Private Fuel Storage, L.L.C.

**EIS COMMITMENT RESOLUTION LETTER #5
DOCKET NO. 72-22 / TAC NO. L22462
PRIVATE FUEL STORAGE FACILITY
PRIVATE FUEL STORAGE L.L.C.**

During the above referenced phone calls, between the NRC and Stone and Webster (S&W), the NRC requested clarification/additional information regarding several topics discussed in the PFS Environmental Report (ER). The NRC requests/questions are documented below along with the PFS response.

DRAWING NUMBER 0599601-EY-4-C

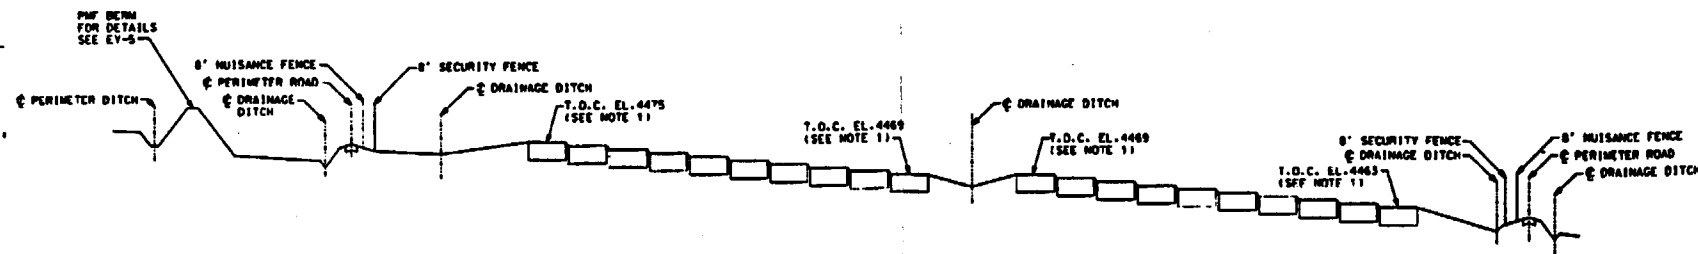
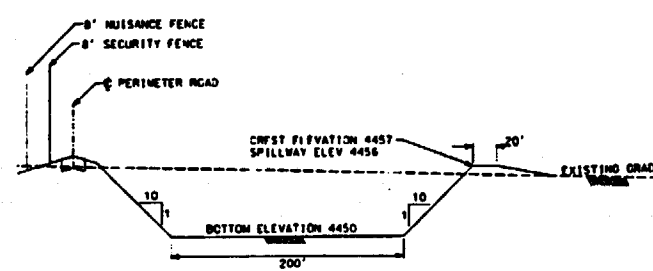
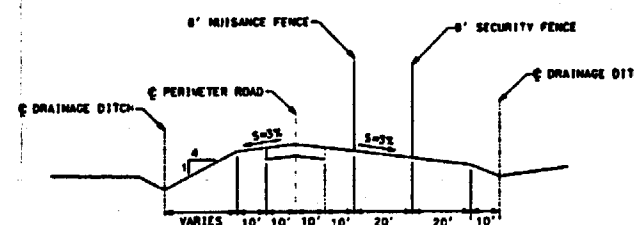
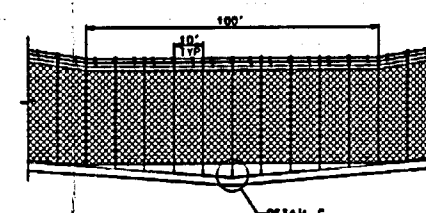
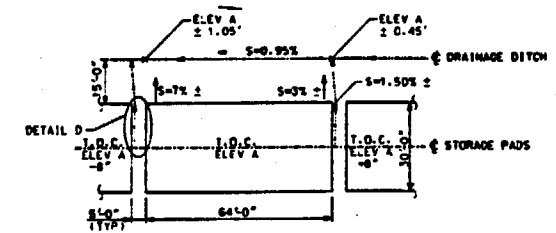
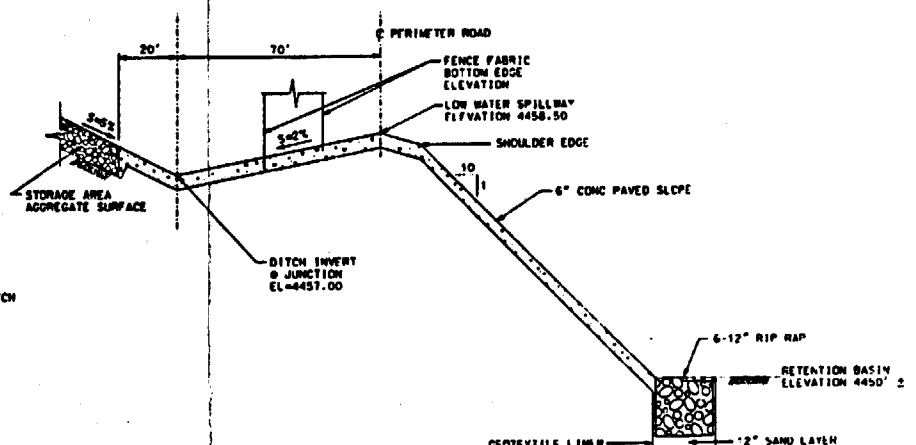
5. PFS needs to provide additional details on the construction of the Detention Basin. Include a discussion of what provisions will be taken to avoid wind and water erosion

of side slopes and provide any drawings that PFS has that shows the design of the basin.

RESPONSE - The detention basin is shown on drawings 0599601-EY-3 and 0500601-EY-4 (see attached copy). The 800' x 200' detention basin located immediately north of the storage area is designed to contain the 100-yr flood. The basin is designed with a concrete inlet from the storage site that precludes erosion from site drainage. The basin is constructed of compacted soil with 10 to 1 side slopes. Side slopes this gradual will reduce the velocity of rainwater flowing into the basin and minimize wind pressure thereby reducing the potential for wind or water erosion. In addition, the basin is located within the 300 wide wildfire barrier that will be planted with crested wheat grass. The presence of the crested wheat grass on the side slopes and bottom of the basin will stabilize the soil and help prevent erosion due to wind or water.

The detention basin is not expected to have standing water except possibly following a severe rainstorm. Water drainage from the storage site from a typical rainstorm is estimated to soak into the ground before it reaches the detention basin. The detention basin was sized for a 100-year flood event in which the depth of water in the basin was calculated to be 4.77 ft. (S&W Calculation No. 0599601-SY-2, Revision 0). In the unlikely event of a 100-yr flood, the time for the water that has collected in the basin to be removed via evaporation and ground percolation is approximately 140 days assuming an evaporation rate of 0.32 in/day (Houghton, Handbook of Applied Meteorology, 1985) and percolation rate of 0.09 in/day (Lambe & Whitman, Soil Mechanics, 1969). If this unlikely event occurred, temporary pumps would be used to drain the detention basin and eliminate long term standing water.

Figure 4.1-1

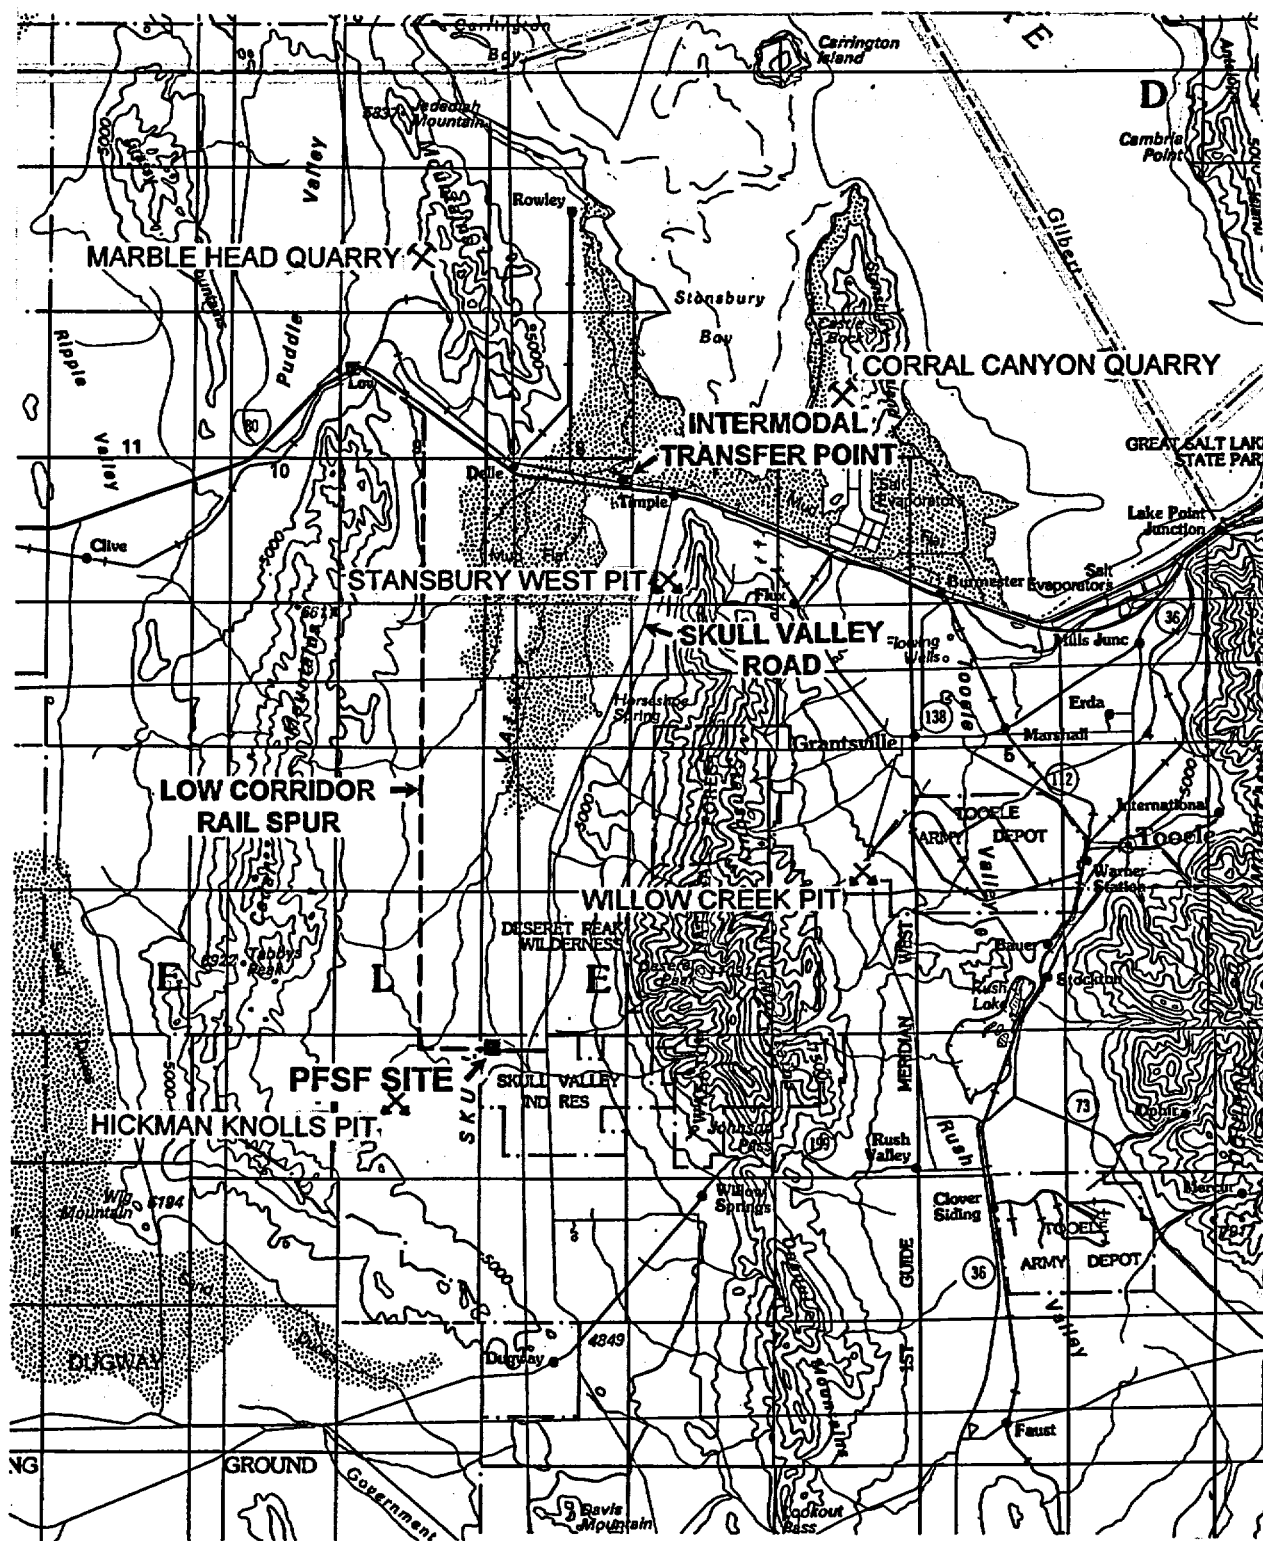
8. PFS should provide a map that shows the location of the aggregate sites in Skull Valley presented in ER Table 4.1-7. Additional information should be provided as to the operational status of each site and the permitting requirements/status of each site.

RESPONSE - A map showing the location of the nearby privately owned aggregate sites as listed in ER Table 4.1-7 is attached and will be incorporated into the next ER revision. For sand and gravel material, currently only the Willow Creek pit is in operation. However, the Stansbury West pit and Hickman Knolls pit can be reopened to provide necessary materials. For the railroad line ballast, only the Corral Canyon Quarry is in operation but the Marble Head Quarry can be reopened to provide ballast materials.
